**Project #22-016  
BSR Roofing Warehouse  
Located at 1097 West 200 South**

*Project Name:* BSR Roofing Warehouse  
*Proponent / Owner:* Jace Skabelund / B. Jace Skabelund  
*Project Address:* 1097 West 200 South  
*Request:* Design Review Permit  
*Current Zoning:* Commercial Services (CS)  
*Type of Action:* Quasi-Judicial  
*Hearing Date:* March 24, 2022  
*Submitted By:* Russ Holley, Senior Planner

Staff recommends that the Planning Commission **conditionally approve** a Design Review Permit for Project #22-016, BSR Roofing, in the Commercial Services (CS) zone located at 1097 West 200 South, TIN #05-107-0012.

Figure 2 shows the site plan

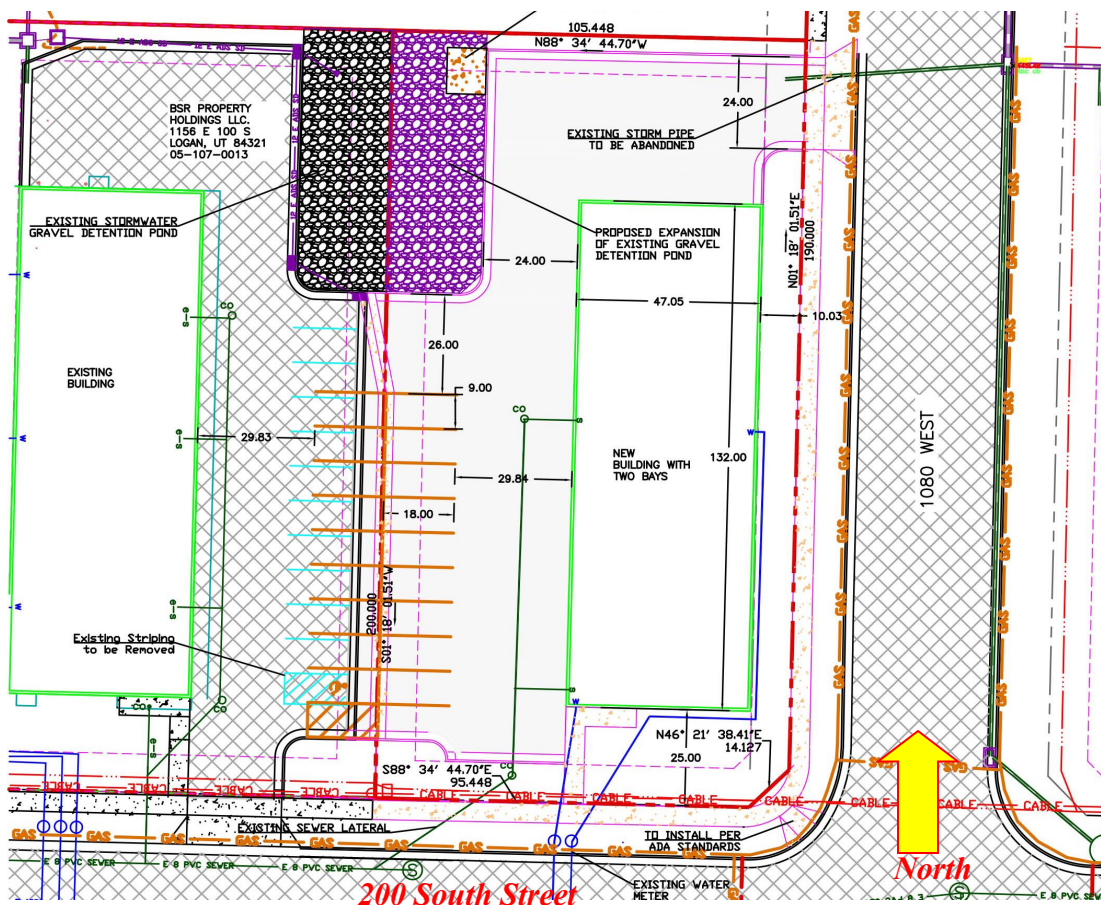
Vehicular driveway access is proposed from 1080 South near the north property corner with a secondary cross-easement access onto 200 South. The parking area runs north-south along the west side of the property. Roll up garage style doors are accessed via the parking area to the west. Pedestrian access to the building from the street is from 200 South along the south façade. As conditioned with a cross-access easement recorded on both properties, the project meets the requirements of the LDC.

3. A cross easement shall be recorded on this property and the property to the west that accommodates this design layout and cross-vehicular circulation.

## EXTERIOR ELEVATIONS

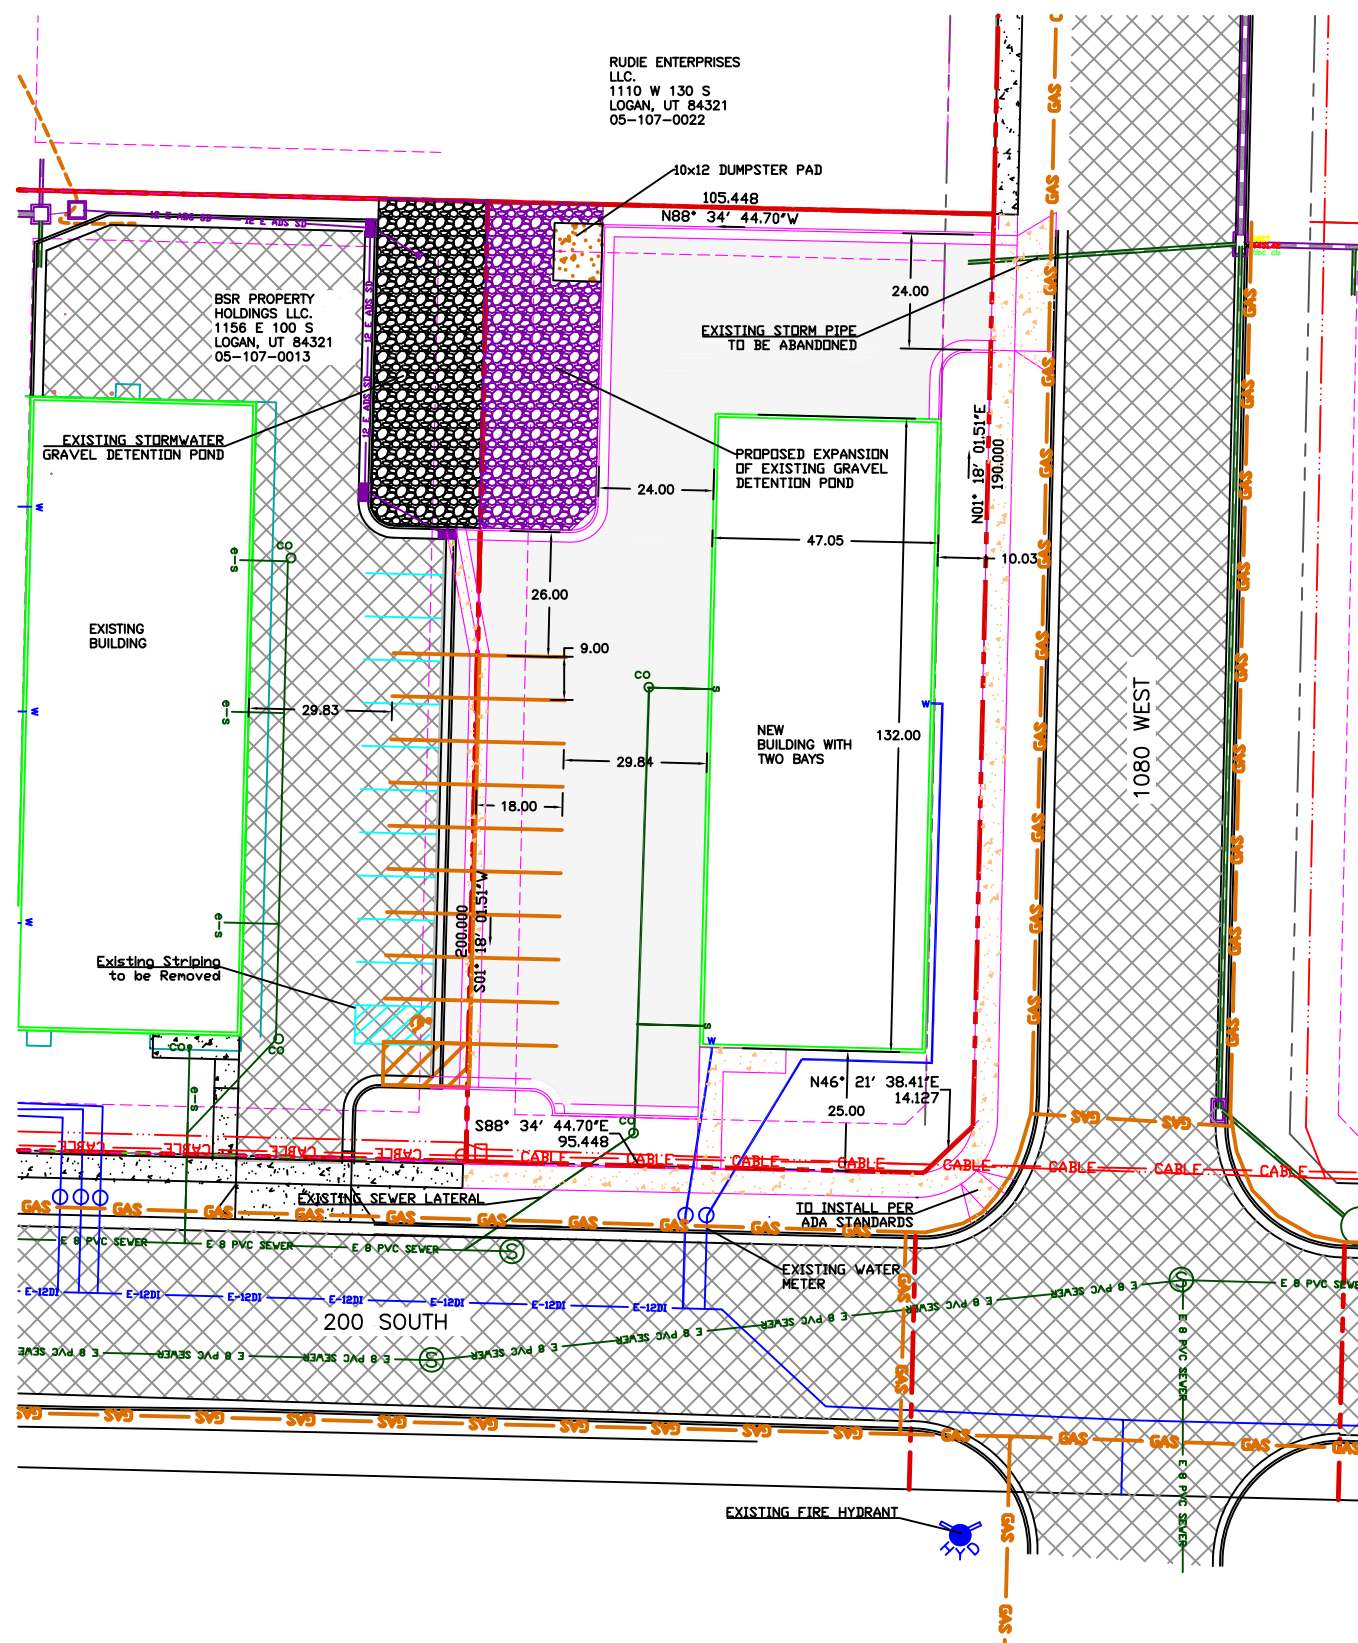
The LDC 17.10.120 & 17.12.060 states that buildings should be designed with interesting forms, colors and materials for visual and architectural character. Blank walls exceeding 40 linear feet is prohibited. Metal building materials should have color coatings that cover the raw material exteriors. The LDC also requires ground floor street-facing facades to have 30% transparency (fenestration). The two-tone metal building shows features at intervals less than 40 linear feet and transparency at 30% on the front façade. The east façade (corner) faces 1080 West Street and is shown with approximately 5% transparency. LDC 17.43.080 allows the Planning Commission to make design related adjustments to approvals if site specific constraints hinder compliance. Design alternatives, like spandrel glass, landscaping, and/or trellis structures may be appropriate to help offset transparency requirements. Design adjustments and alternatives are typically given by the Planning Commission when the proposal is close to meeting code requirements. This proposal is not close. As conditioned with additional transparency on the east facade, the project meets the LDC requirements.

1. All standard conditions of approval will be recorded with the Design Review and are available in the Community Development Department.
2. The east façade shall have 30% transparency unless the Planning Commission approves an alternative as per LDC 17.43.
